Access Compliance Report Public Rights-of-Way (Curb Ramps)

Main Street: SILVER_FOX_RD Cross Street: KEMPTON_DR Location: NE

ADA ID: RPRK211208124218 Ramp Type: Type 1 - Perpendicular Diagonal Initial Pass/Fail: Fail Overall Compliance: No Severity Score: 2

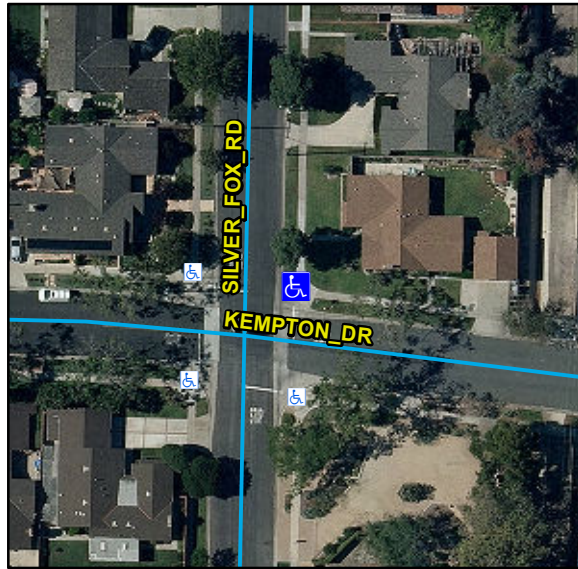
Compliance	Description	Data	Compliance	Description	Data
N/A	Ramp Length (in)	82	N/A	Flare Type LT	
Yes	Ramp Width (in)	48			N/A
Yes	Ramp Run Slope (%)	6.2	N/A	Flare Slope LT (%)	N/A
No	Ramp Cross Slope (%)	2.3	N/A	Flare Traversable LT	N/A
N/A	Landing Present	N/A	N/A	Flare Type RT	
N/A	Landing Length (in)	N/A			N/A
N/A	Landing Width (in)	N/A	N/A	Flare Slope RT (%)	N/A
N/A	Landing Run Slope (%)	N/A	N/A	Flare Traversable RT	N/A
N/A	Landing Cross Slope (%)	N/A	N/A	DWS Provided	N/A
N/A	Landing Movement Obstructed?	N/A	N/A	DWS Contrast	N/A
	Landing Movement Type	N/A	N/A	DWS Length (in)	N/A
N/A	Landing Shared	N/A	N/A	DWS Full Width	N/A
N/A	Clear Space	Yes	N/A	DWS Offset Left (in)	N/A
N/A	Clear Space To Crosswalk (in)	N/A	N/A	DWS Offset Right (in)	N/A
N/A	Marked Crosswalk 1	No	N/A	Marked Crosswalk 2	No
	Crossing 1 Direction	W		Crossing 2 Direction	S
	Marked Crosswalk 1 Width (in)	N/A		Marked Crosswalk 2 Width (in)	N/A

N/A	Ramp Inside Crosswalk 1	N/A	Yes	Ramp Inside Crosswalk 2	N/A
	Crossing 1 Slope (%)	2.8		Crossing 2 Slope (%)	1.9
	Crossing 1 Cross Slope (%)	1.6		Crossing 2 Cross Slope (%)	3.6
N/A	Gutter Ponding	N/A	N/A	Curb Slope	4.3
No	Gutter Lip Height (in)	0.25		Road Run Slope (%)	1.7
N/A	Gutter Run Slope (%)	N/A		Road Cross Slope (%)	2.3
N/A	Gutter Cross Slope (%)	N/A			
Yes	Overall Surface Condition: Acceptable		No	Perp Joint Present	No
	Cross Gutter Present?	Yes		Spandrel Present?	Yes
	Replace Cross Gutter?	No		Replace Spandrel?	No

Remove & Replace Curb Ramp With Two New Directional Ramps or Equivalent. Grind Gutter Lip.
